PLANS AND DOCUMENTS referred to in the PDA DEVELOPMENT APPROVAL

Approval no: DEV2025/FLA/4175
Date: 06 February 2026

PROJECT
HERCULES STREET

SITE ADDRESS
19 HERCULES ST HAMILTON, BRISBANE QLD 4000

DRAWING TITLE
LEVEL 20

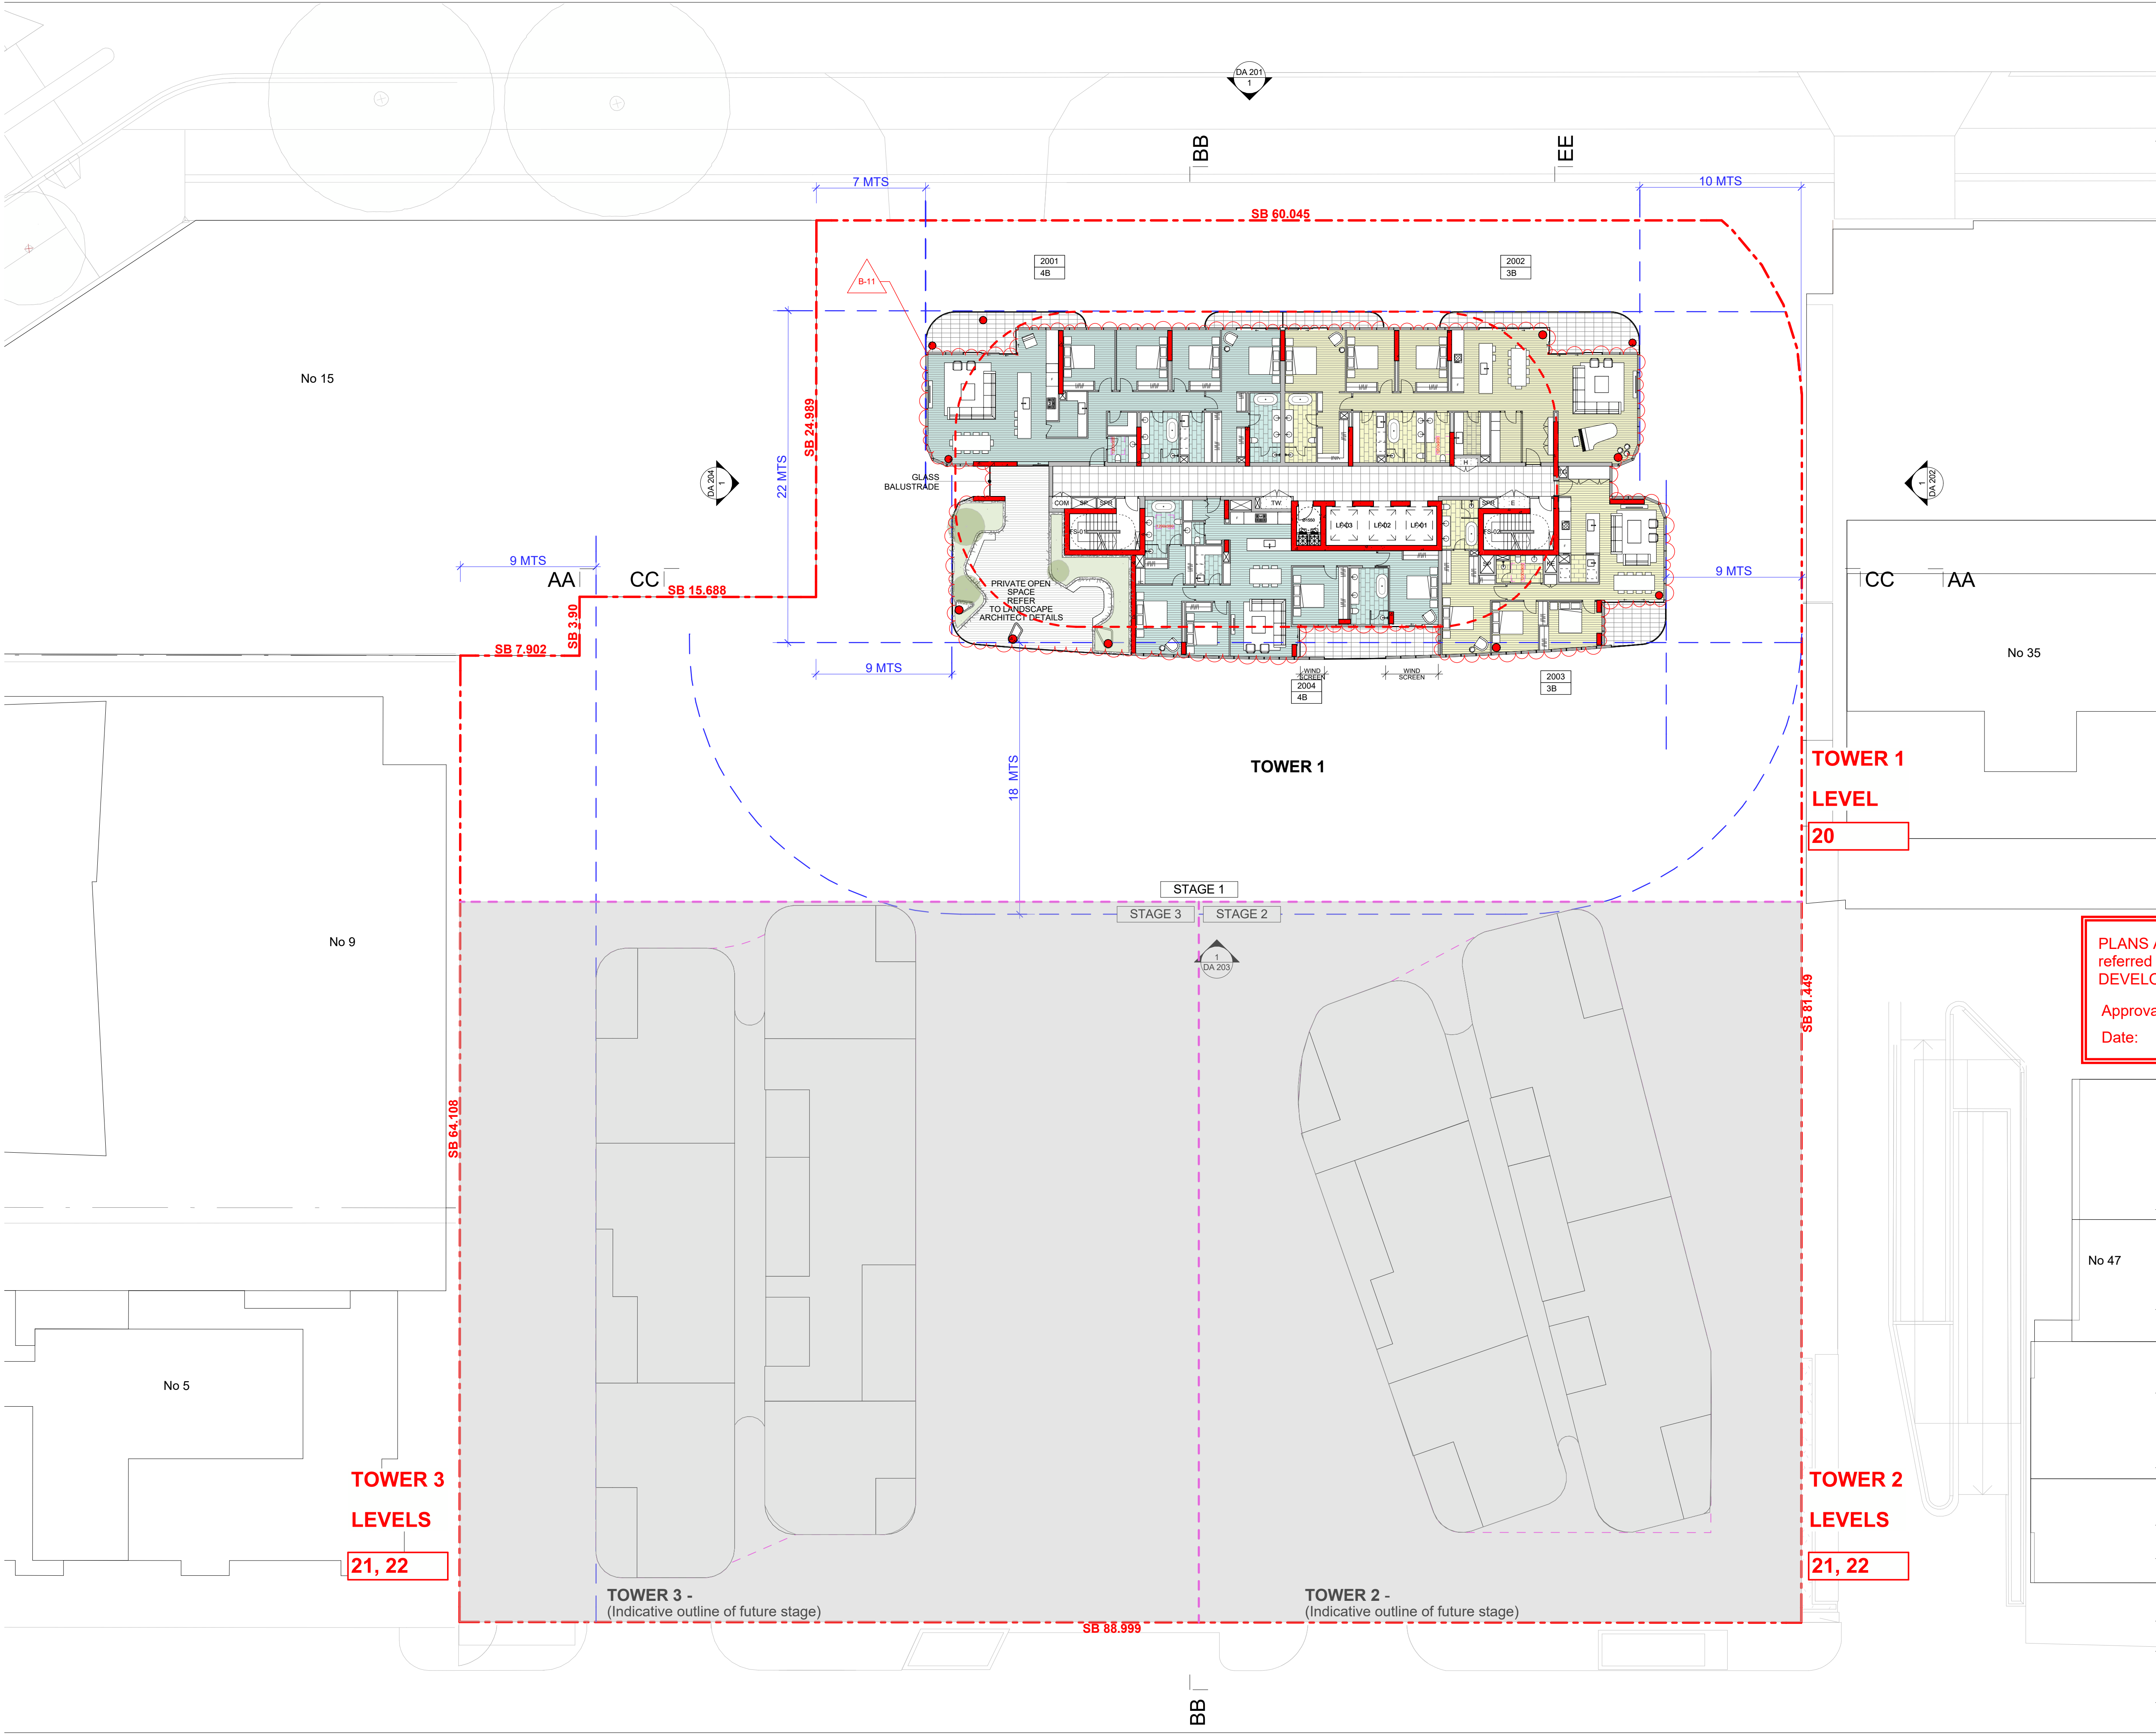
CHANGE	DESCRIPTION
B-11	INTERNAL LAYOUT AND SKYGARDEN LANDSCAPE OPTIMIZED

DRAWING TITLE
LEVEL 21

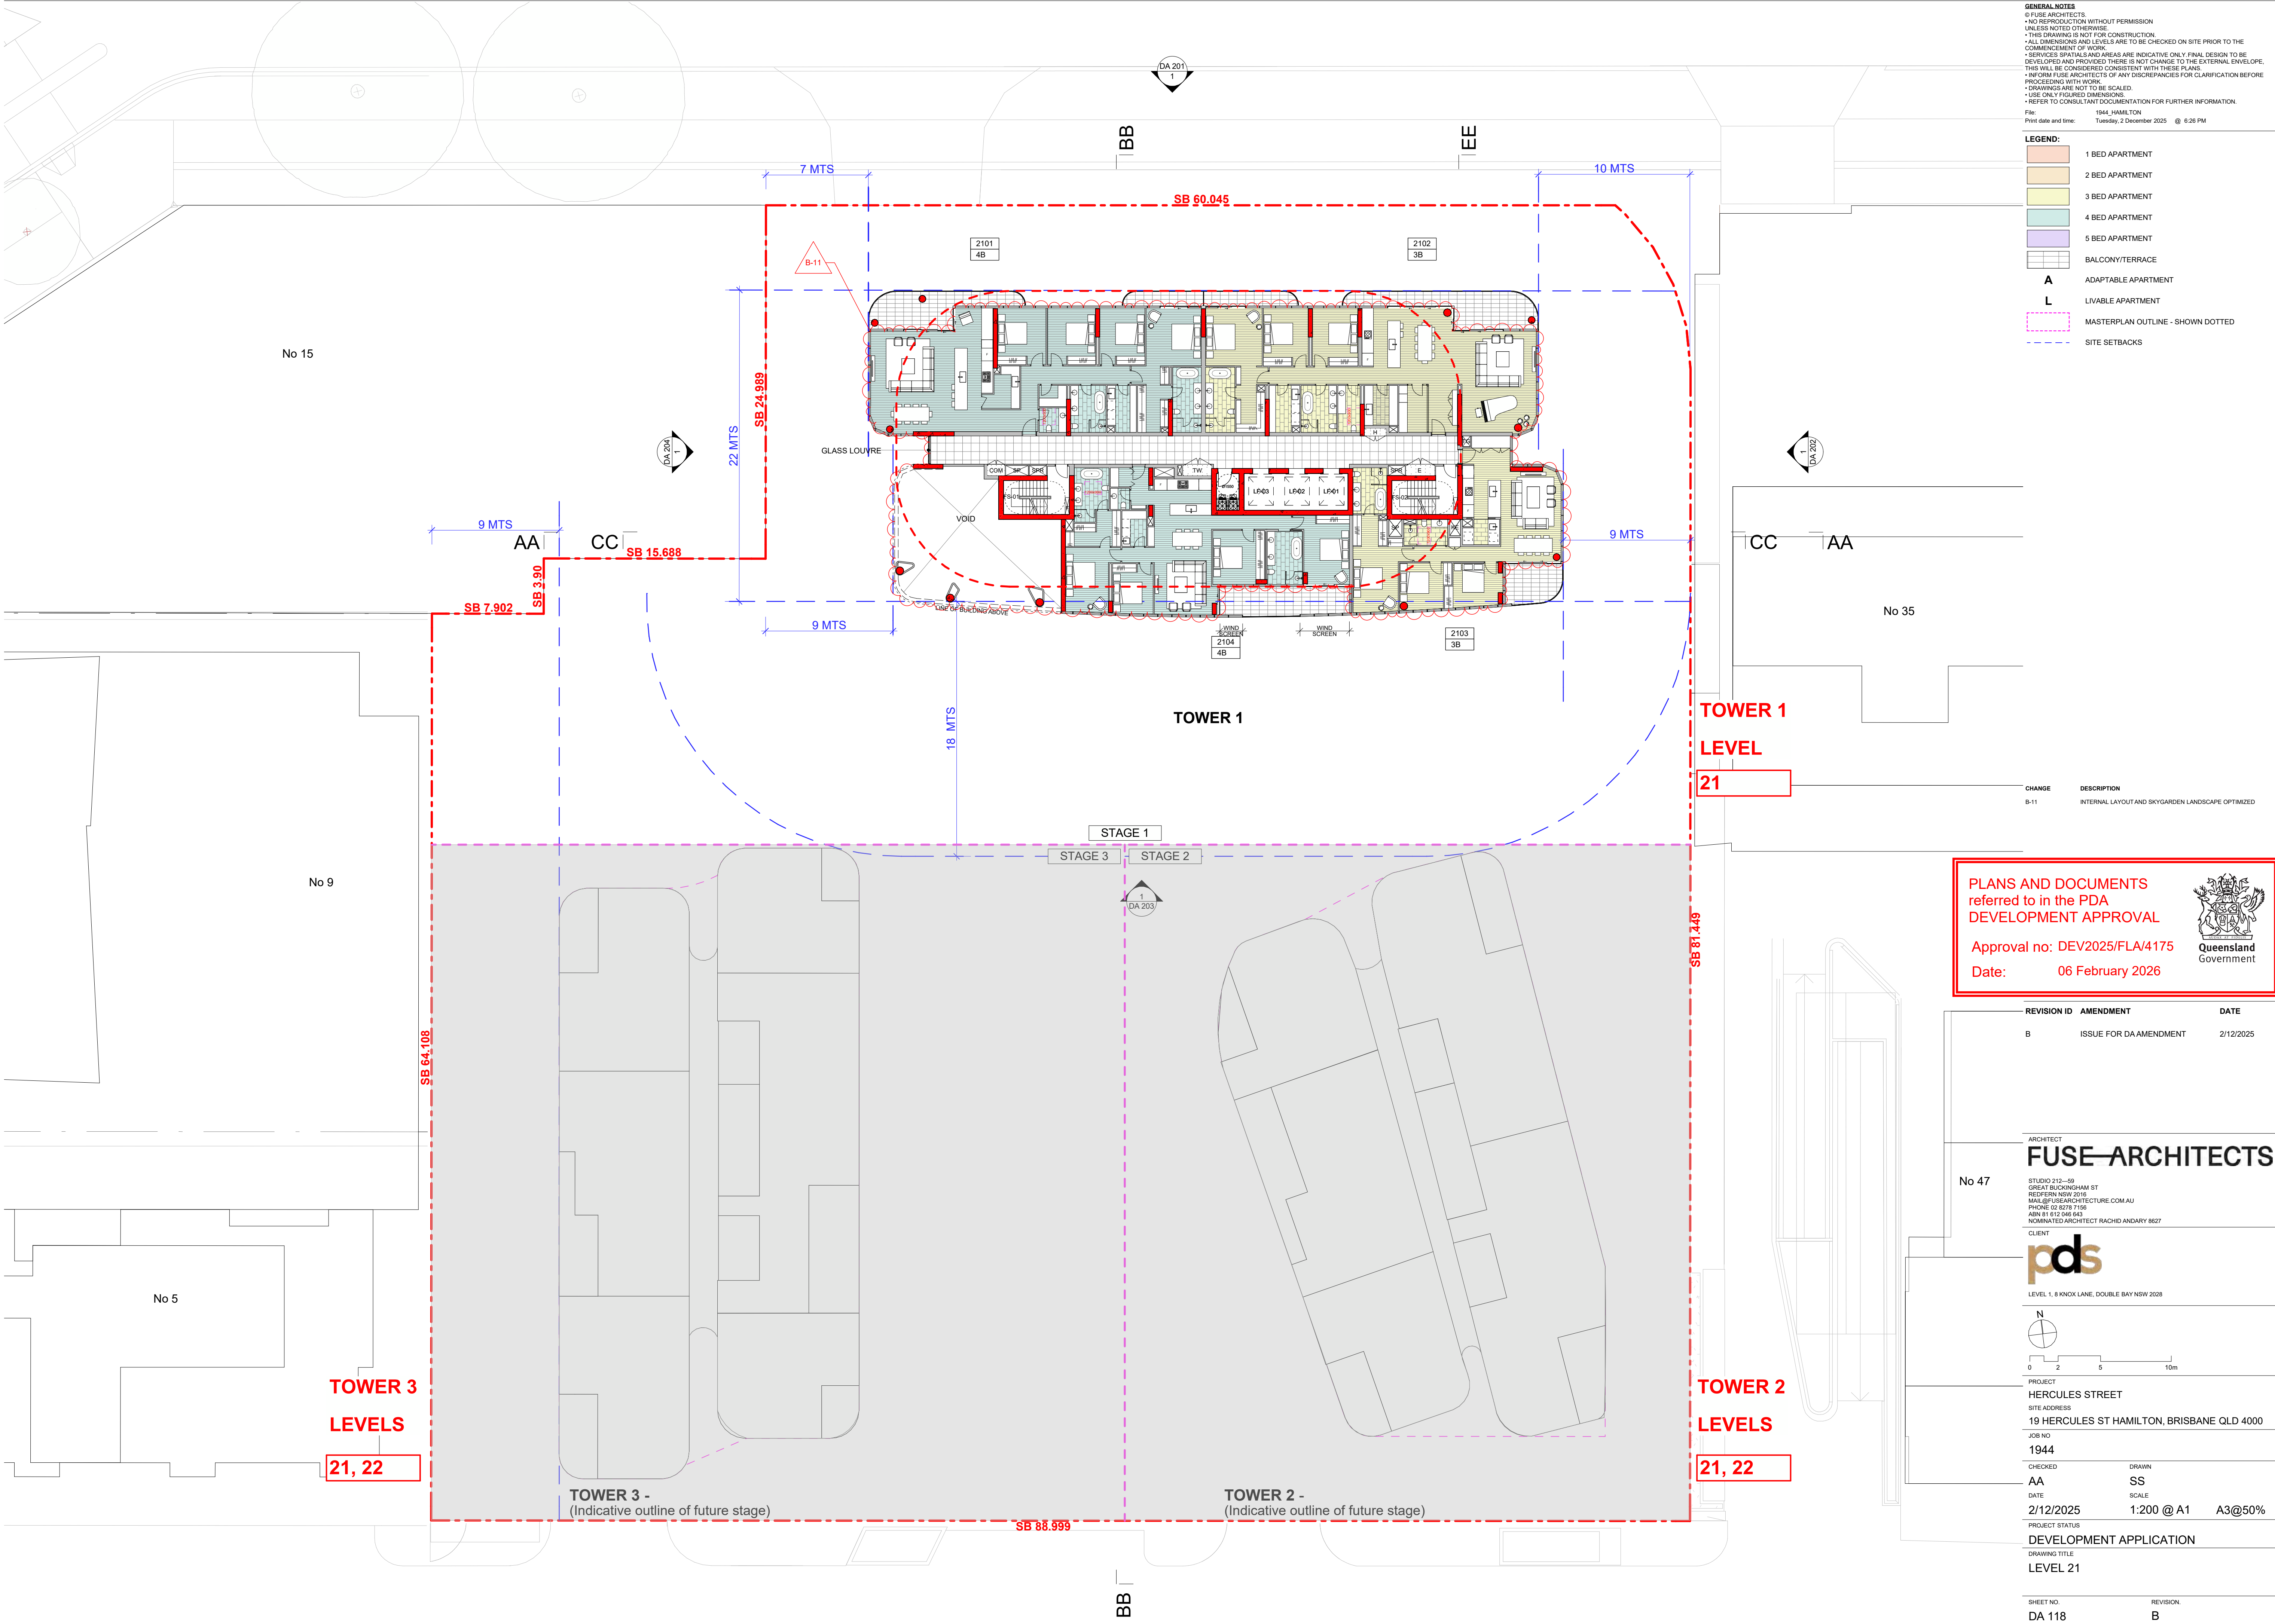
CHANGE	DESCRIPTION
B-11	INTERNAL LAYOUT AND SKYGARDEN LANDSCAPE OPTIMIZED

DRAWING TITLE
LEVEL 22

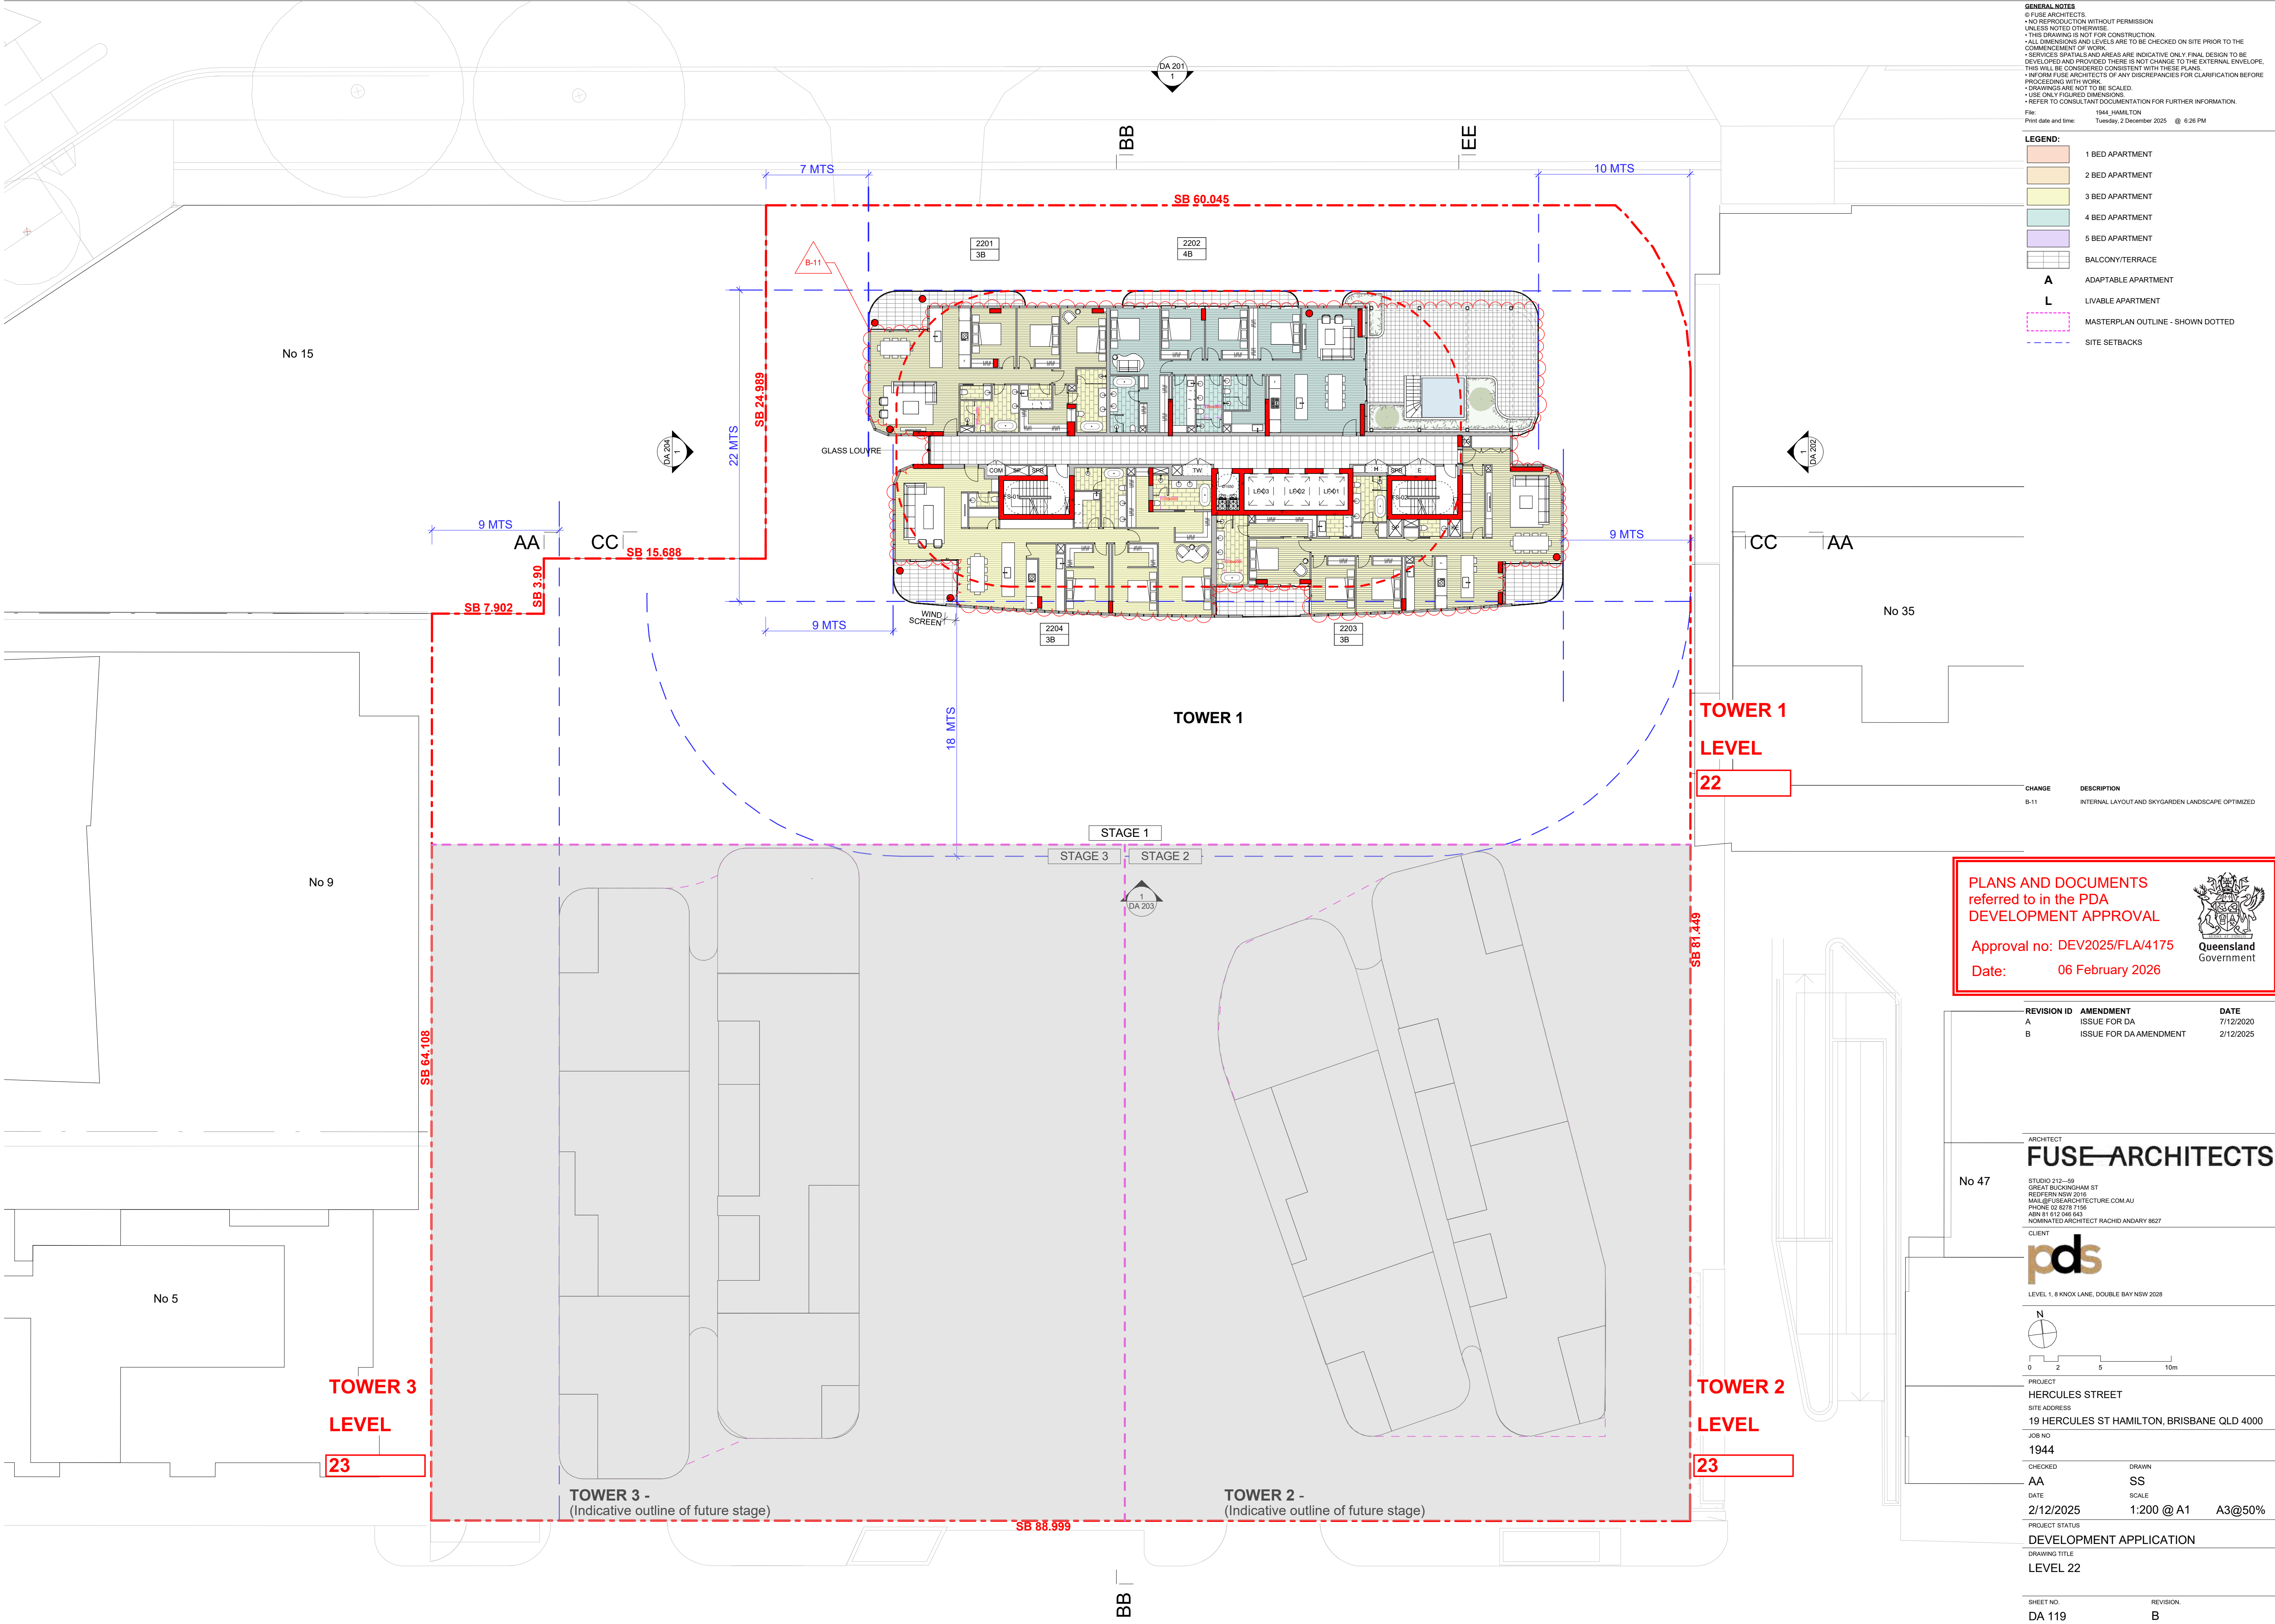
CHANGE	DESCRIPTION
B-11	INTERNAL LAYOUT AND SKYGARDEN LANDSCAPE OPTIMIZED
